CONTINUING ELIGIBILITY INSPECTION (CEI) REPORT
FOR FLOOD CONTROL PROJECTS

1. Project Name: KK Dam Flood Control Project

2. Date of Inspection: January 14, 2003

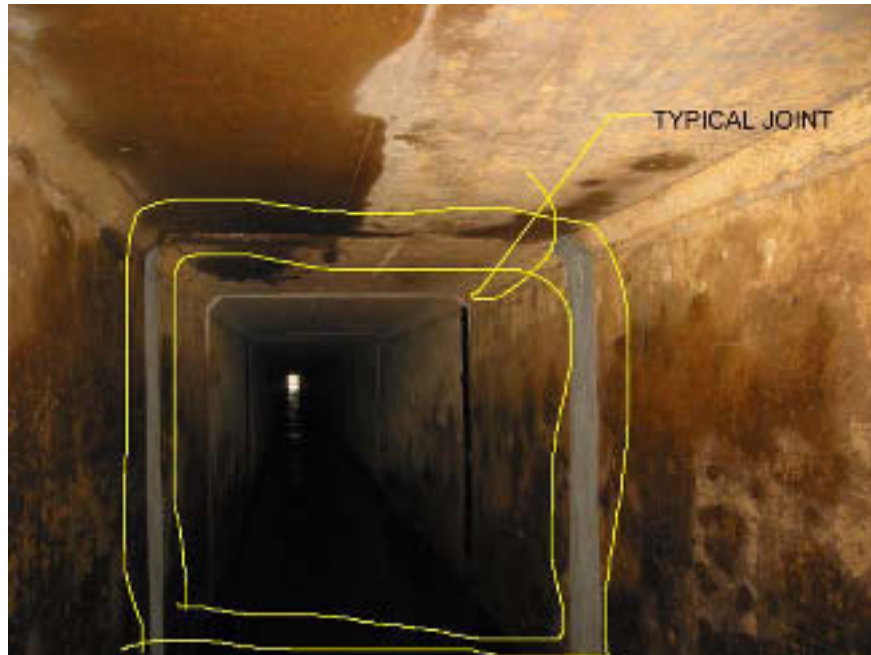
Continue to monitor leak in sluice gate at bottom of intake tower entrance shaft. Elodea Densa observed hanging on ladder rungs.

Continue to monitor leak at sluice gate bottom corner.

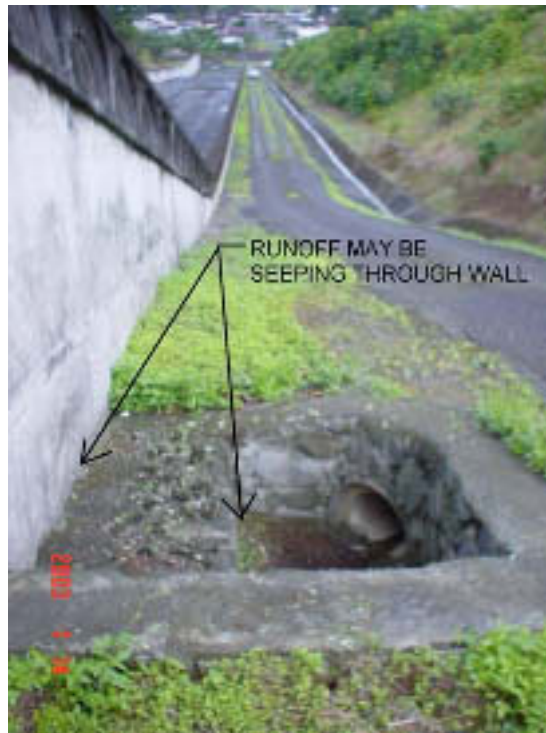
Sta. (-)0+70, Right Wall, Monitor seepage through wall. Monitor area.
